Proposed Residential Development, Glen Dimplex, Stoney Lane, Whiston – Transport Technical Note 01 – July 2026

- 1 BTG Eddisons has been instructed by Taylor Wimpey to advise on the traffic and transport issues relating to the proposed residential development on land at Stoney Lane in Whiston (Planning Ref: 25/00672/FUL).
- 2 This Transport Note has been produced in response to the consultation responses received from Knowsley Metropolitan Borough Council (KMBC) on 24th May 2026.

DRAWING TITLE: PROPOSED SITE ACCESS

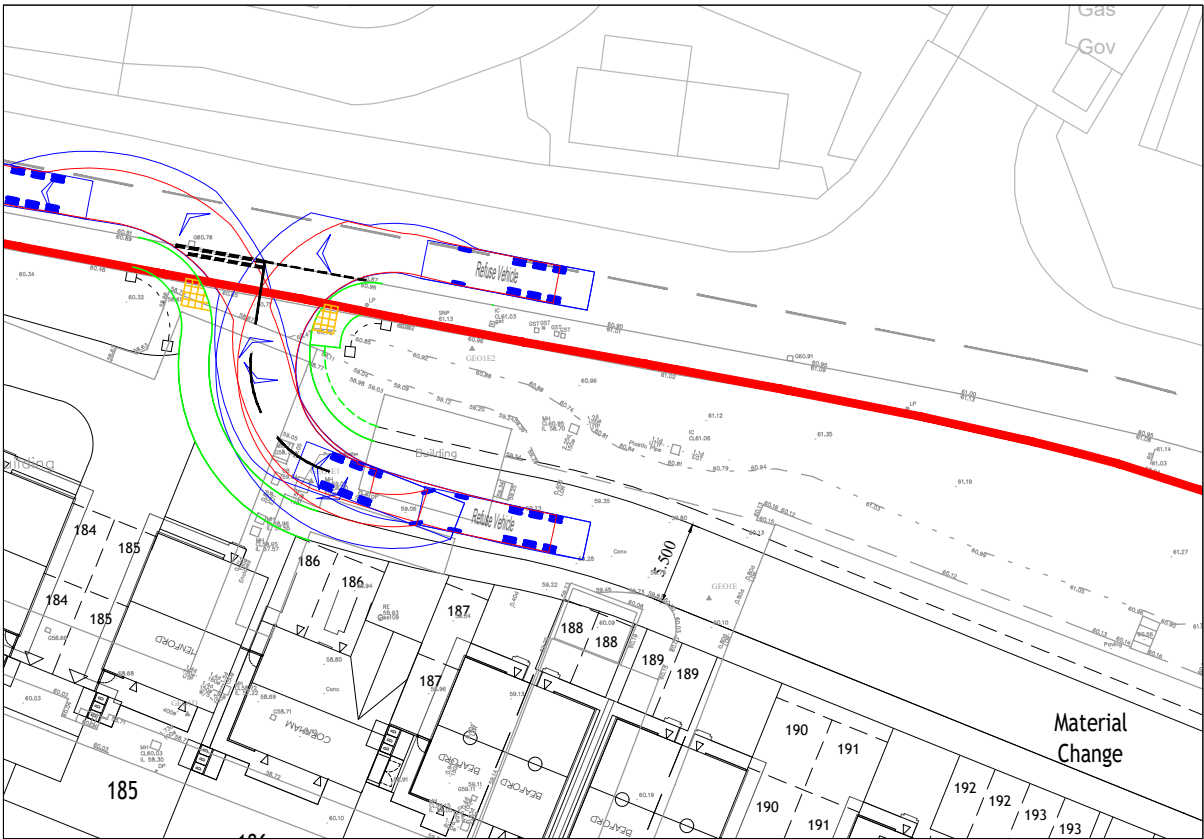
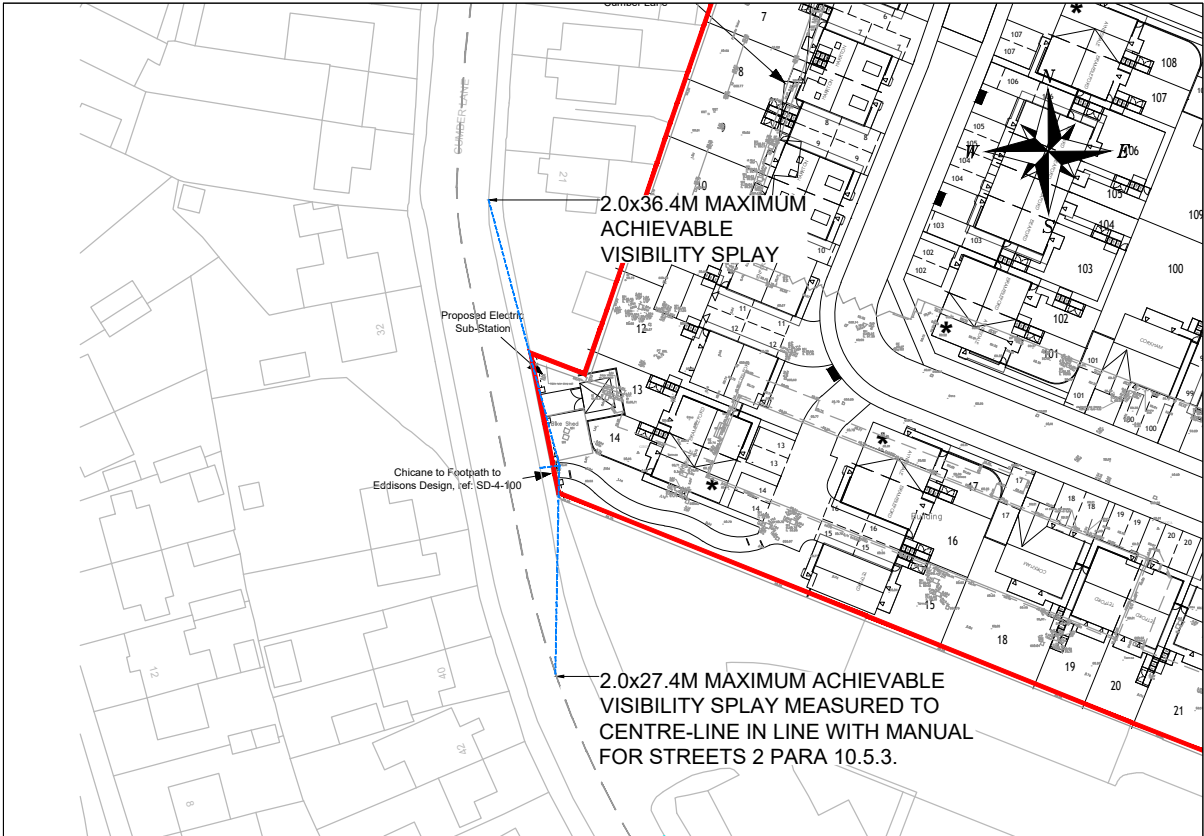
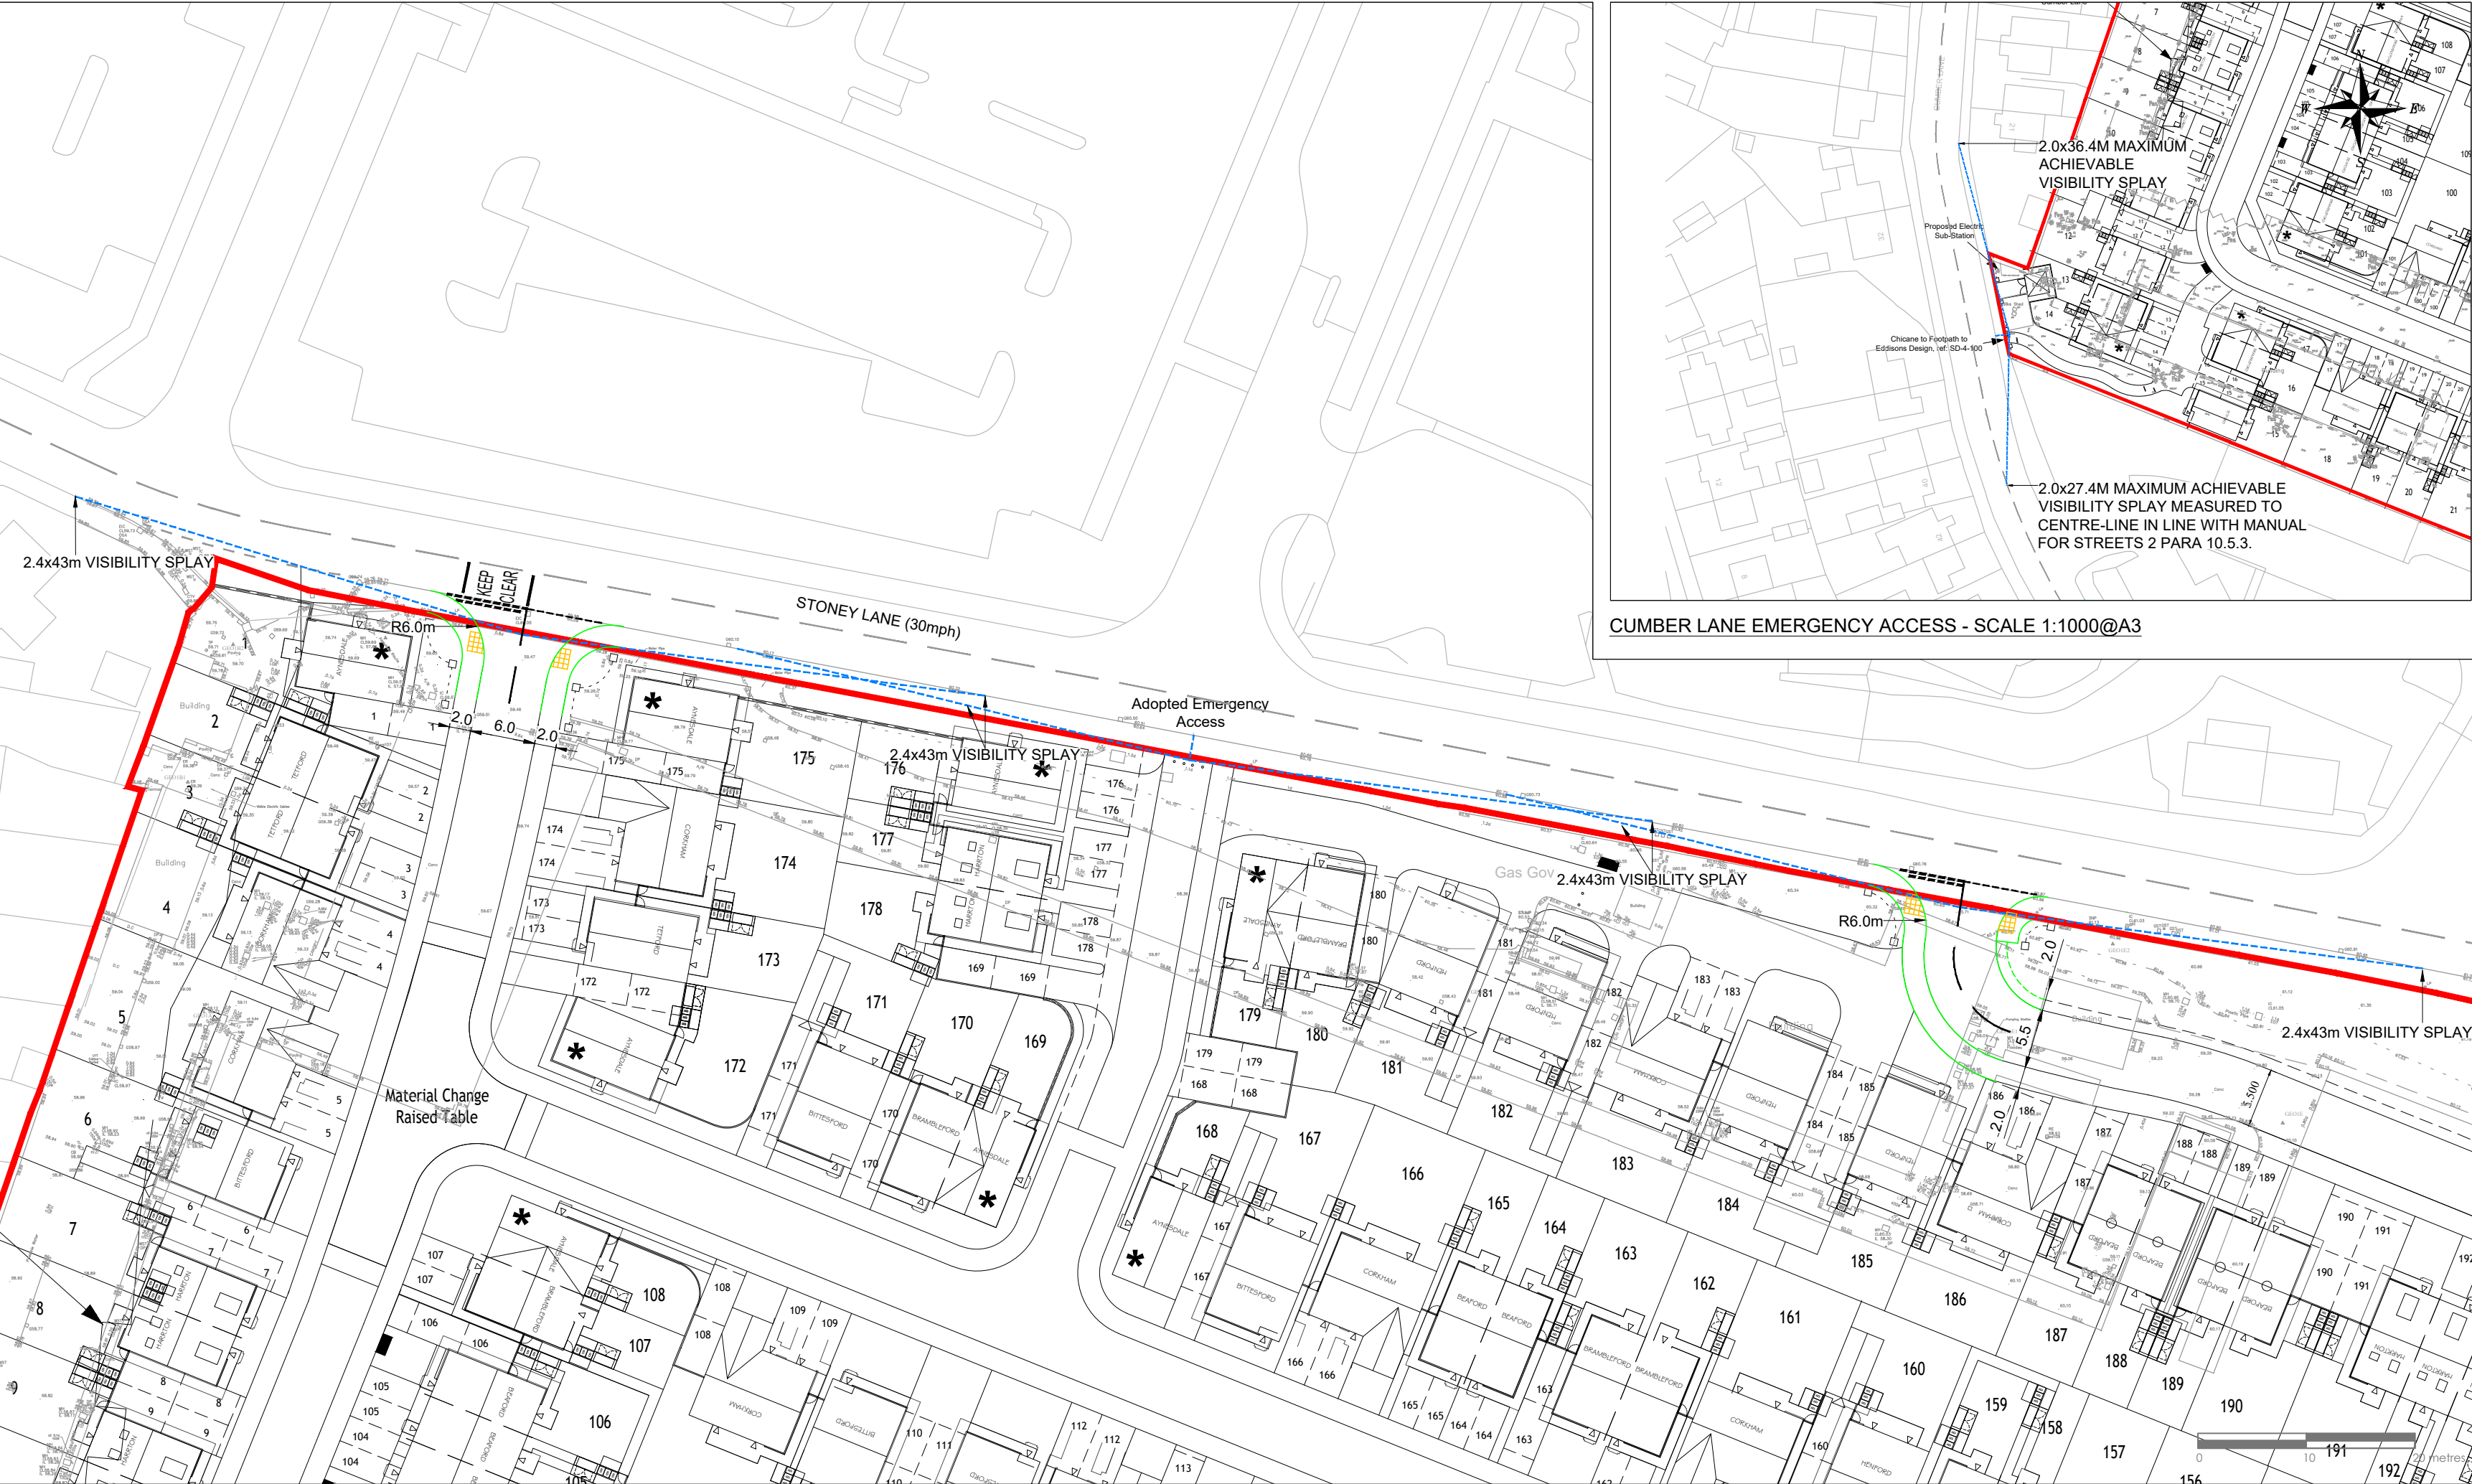
“At pre-application stage, highways raised concern regarding the positioning of any residential access opposite the operational accesses serving the Ambulance Station on Stoney Lane. Although the applicant has marginally repositioned the access serving the cul-de-sac fronting Stoney Lane, the revised location now sits almost directly opposite the ambulance station’s eastern access. This remains unacceptable.

Routine residential turning movements would directly conflict with emergency vehicle egress, particularly during blue-light departures where ambulances require immediate, unobstructed priority. Opposing accesses in such close proximity increase driver hesitation, complicate decision-making, and introduce avoidable obstruction risk. Given that there is a clear length of frontage between the ambulance station’s two accesses where a residential junction could be positioned without directly opposing either, the current arrangement represents a design choice rather than a constraint.

The access should therefore be repositioned to remove direct conflict with emergency operations and maintain a predictable, low-conflict highway environment.”

"The planning layout shows a number of "emergency-only" vehicular accesses around the site perimeter, significantly more than would normally be required for a development of this scale. While pedestrian and cycle permeability is strongly supported, the number of vehicular emergency accesses proposed is excessive and unjustified.

The emergency accesses positioned on Stoney Lane create unnecessary frontage breaks, undermine hierarchy, and increase the likelihood of informal vehicular use over time. Standard practice would typically expect no more than one well-located emergency vehicular access if deemed it was required operationally. If a single emergency vehicular access is required, the access located near Plot 138 is the preferred location. The emergency access strategy therefore requires rationalisation, with vehicular emergency access reduced to a single appropriate location, and all other boundary breaks redesigned as pedestrian and cycle links only.

All other boundary breaks currently shown as "emergency access" should be removed or redesigned for pedestrian/cycle use only. Any retained emergency access must be supported by a clear, enforceable management plan and all must show that they meet current visibility requirements on a scaled plan"

- 5 The site access is now positioned approximately 15 metres to the west, as shown on **Plan 1**.

- 7 The revised emergency access will be located between the two access points by Plot 176 is shown on **Plan 1**. The emergency vehicular access will be adopted.

64 The revised vehicular access arrangement is shown on Plan 1.

109 The amended site access arrangement incorporating the recommended 'Keep Clear' markings is shown on Plan 1.

DRAWING TITLE: SWEPT PATH ANALYSIS
REFUSE VEHICLE

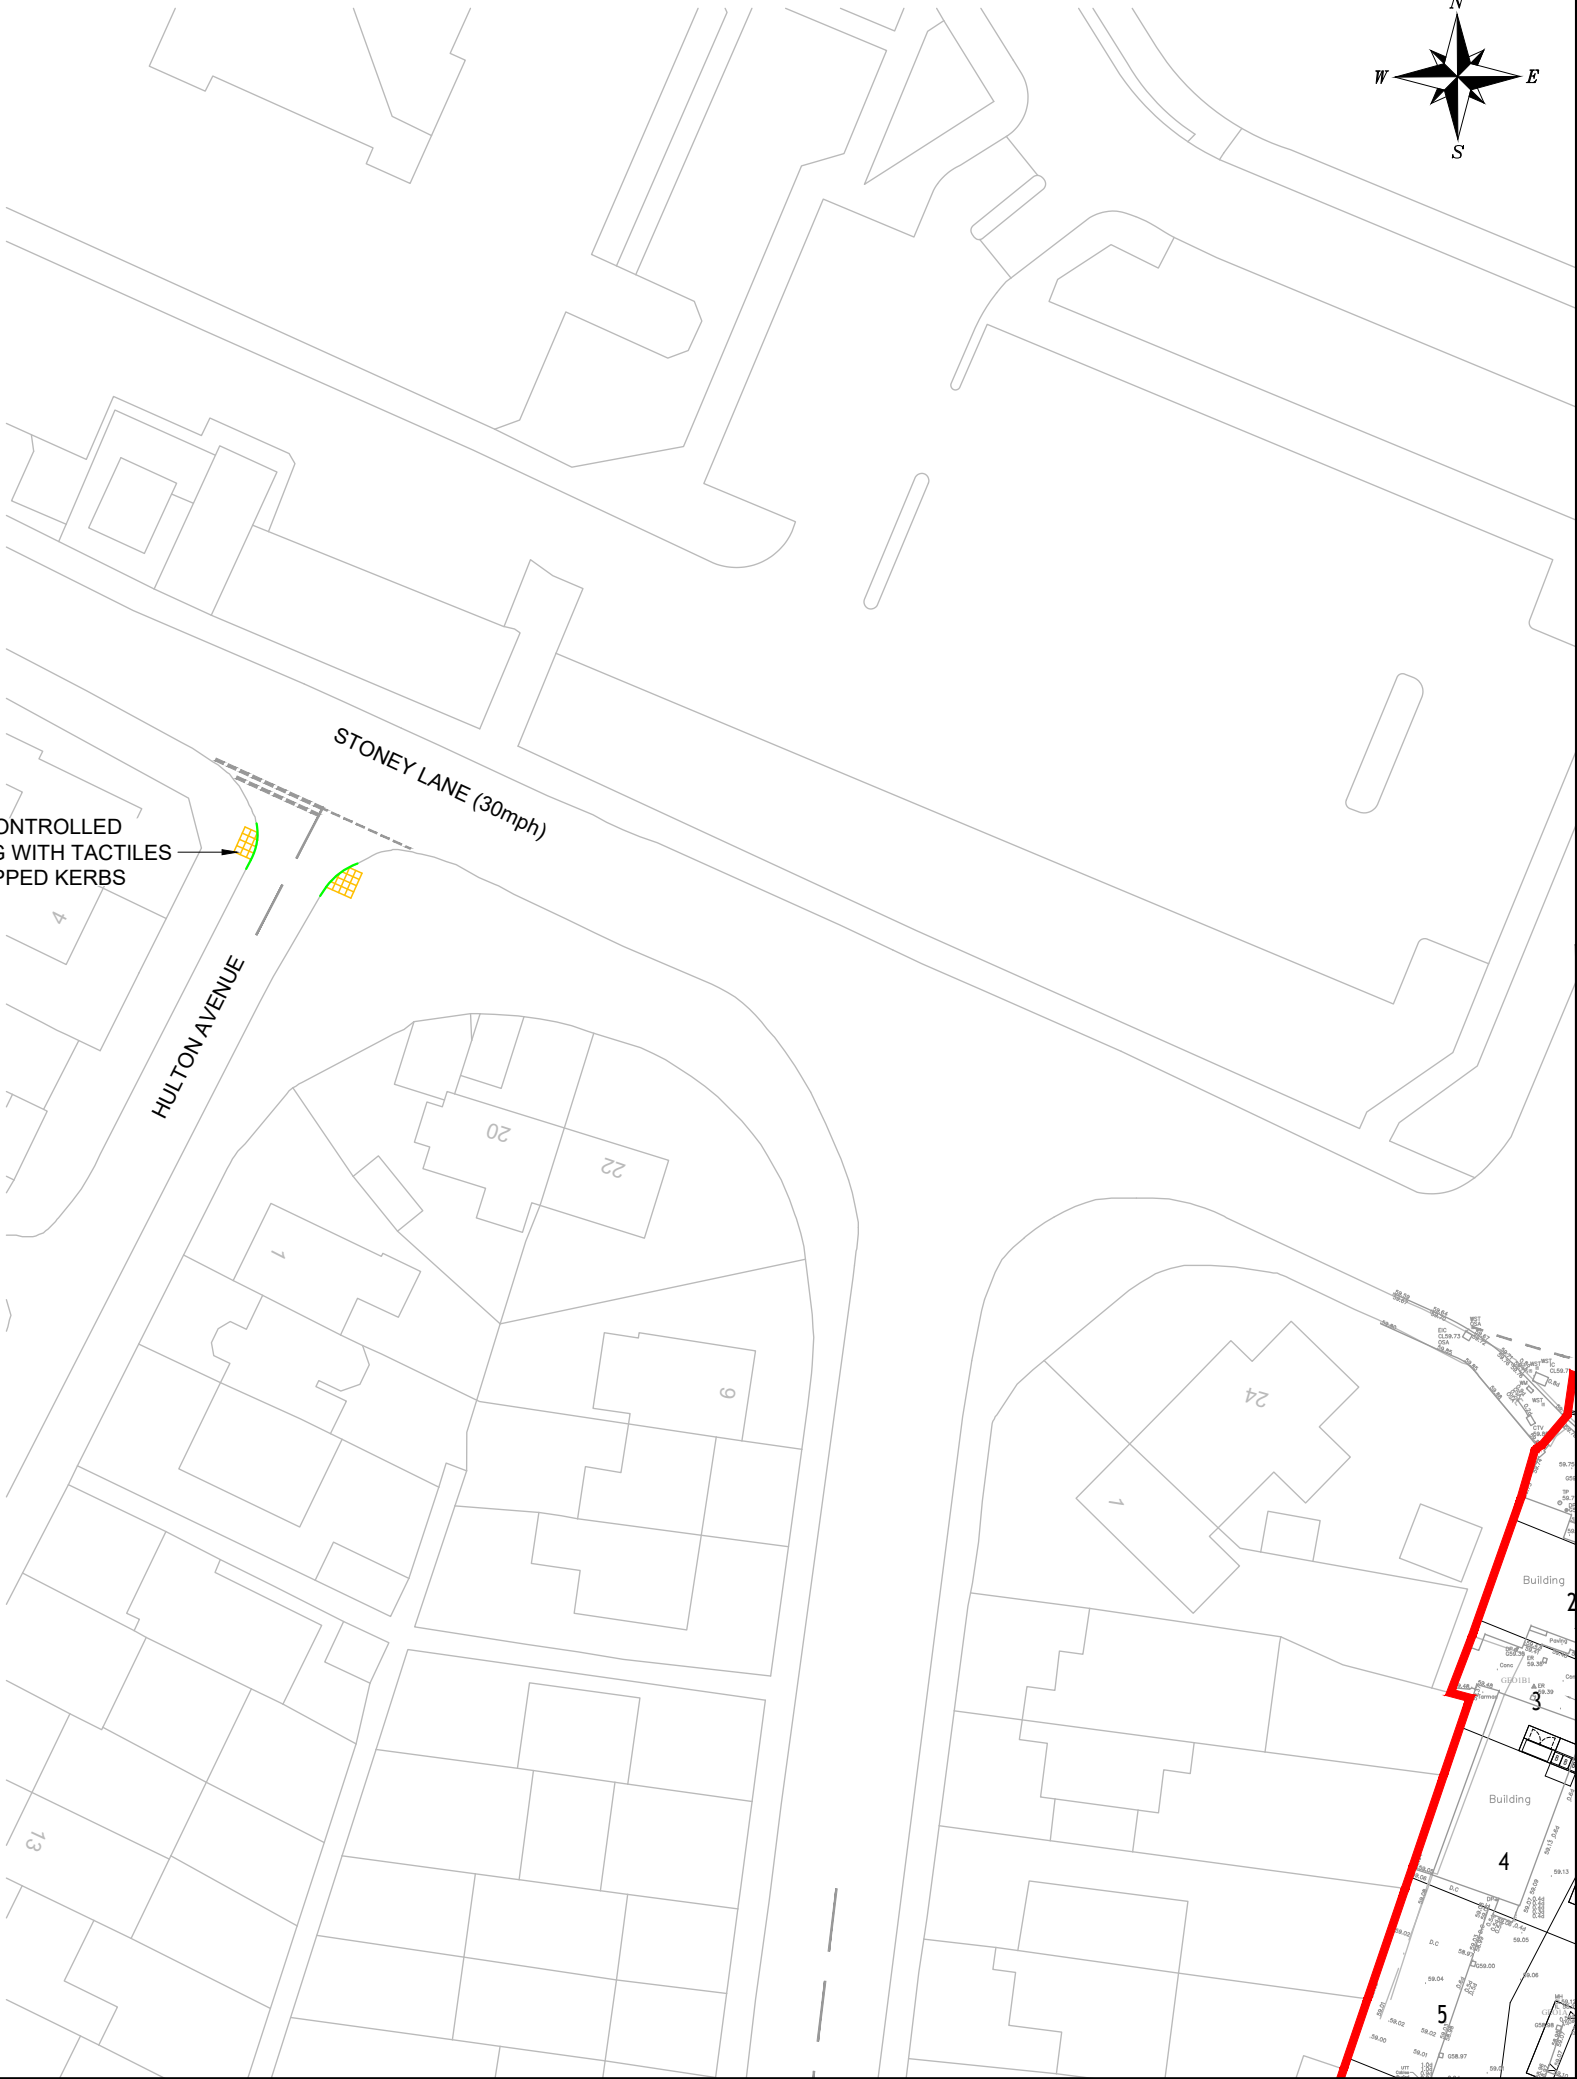
"Of particular concern is the swept path at the cul-de-sac access fronting Stoney Lane, where the tracking for the refuse vehicle demonstrates significant overrun across the full width of the junction, fully encroaching into the area of pedestrian waiting space at the junction, including the tactile paving, thereby removing any safe standing area for pedestrians awaiting a crossing opportunity. This compromises the safety of anybody standing at the tactile crossing area. Further to this, the swept path drawings show that refuse vehicles exiting the estate from both accesses onto Stoney Lane are required to significantly overrun opposing lanes to a degree that exceeds what would normally be considered acceptable onto a busy distributor road. These arrangements present an unacceptable risk at a location that already experiences high pedestrian activity.

- 61 The swept path analysis for both the refuse and fire appliance vehicles has been amended to minimise encroachment into opposing lanes. In addition, the turning areas and private drives have been redesigned to ensure that bin collection points are within 25 metres of an adopted collection point.
- 62 The swept path analysis for refuse is shown in **Plan 5**, whilst the swept path analysis for the fire appliance vehicles is shown in **Plan 6**.
